## **Service Bulletin**

**No. :** MZ07-060

**Model:** SR4001, SR5001 SR7001, SR8001

**Subject:** A component configuration change: TUNER MODULE and FM ANTENNA only for the US version.

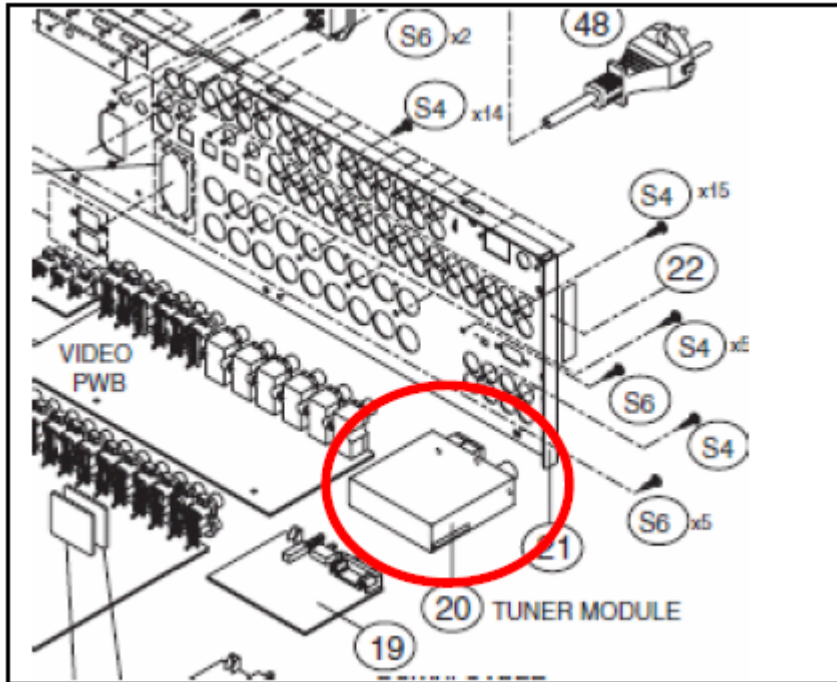
**Symptom:** The configuration of the FM Antenna Terminal was changed from the APL/F common connector to the F Connector.

**Solution:** 1. Change of TUNER MODULE  
POS.NO. 20 SR4001, SR5001  
POS.NO. 60 SR7001, SR8001

**OLD: TUNER MODULE**  
**PART NO. 90M-AV000410R**

**NEW: TUNER MODULE**  
**PART NO. 90M-AV000570R**
